(Parent) Project Number: D21-00004
Project Name: Tri-City Psy Development
Project Planner: Scott Nightingale

Application Review Committee Division Comments

Project description: Tri-City Psychiatric Development @ 4002 Vista Way

Subject: Application Review Committee (ARC), **Initial** Submittal for the Tri-City Psychiatric Development @ 4002 Vista Way (D21-00004 & CUP21-00004); APN: 166-010-43, 31

Figure 1: G-14E

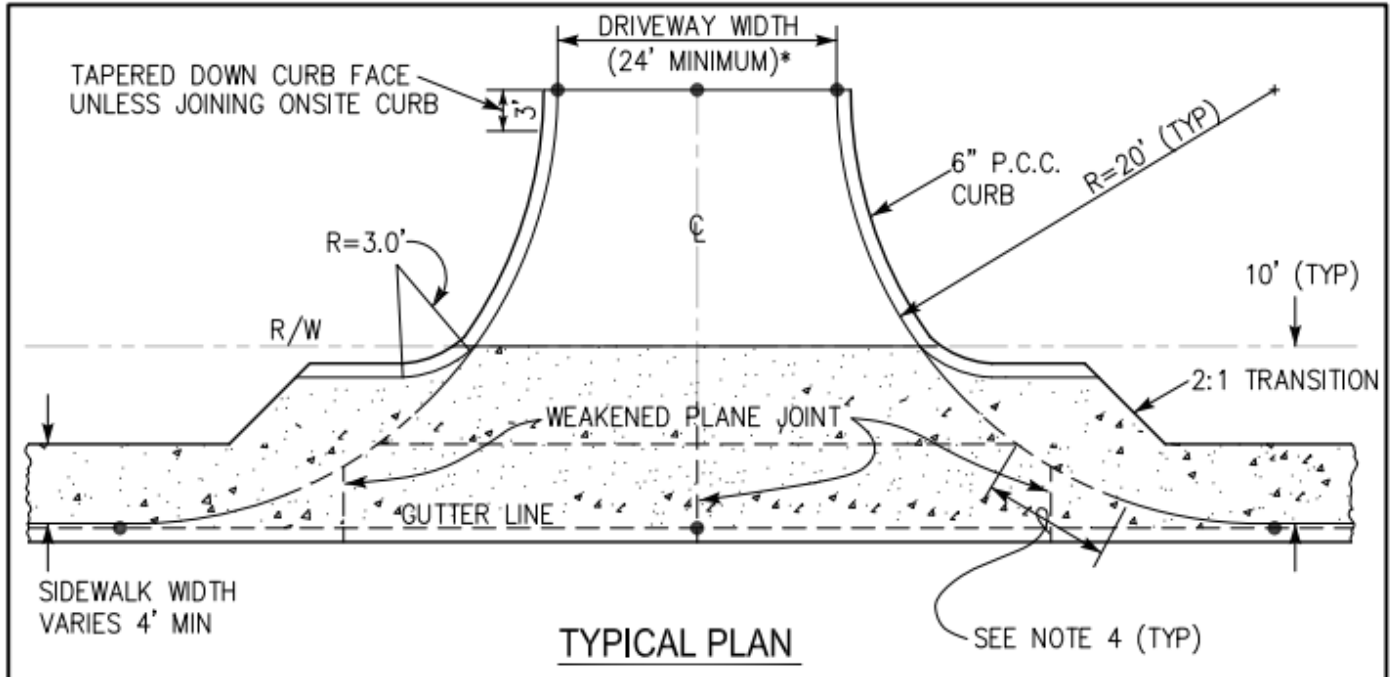
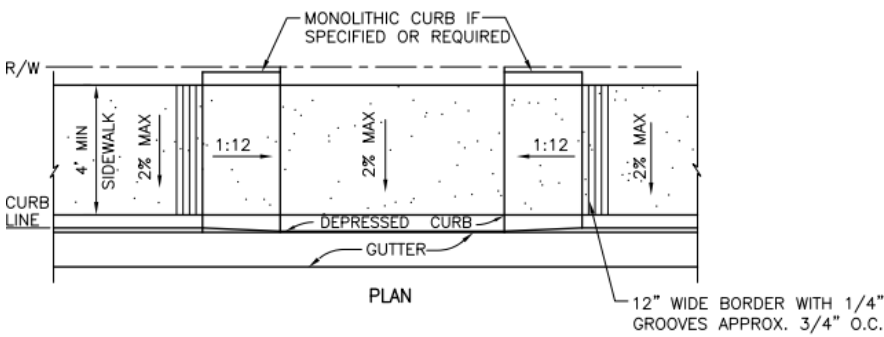
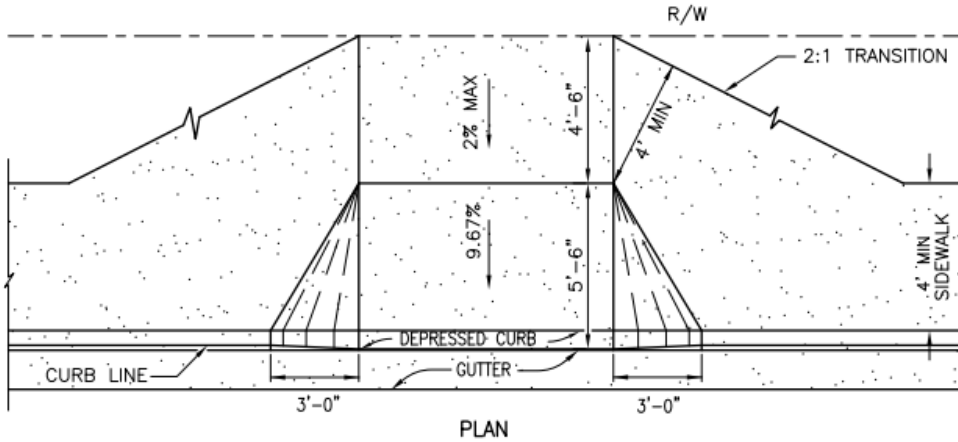
21. Provide a San Diego County Regional Standard for the proposed drive way. *Currently proposing City of Oceanside standard driveway which is similar to an “alley-type” driveway per G-14E (see below). Please confirm City of Oceanside is acceptable as shown in plan. If standard driveway is provided no ADA Curb Ramps may be provided along Waring Road as indicated in previous comments. (see smaller options G-14D and G-14A below)*
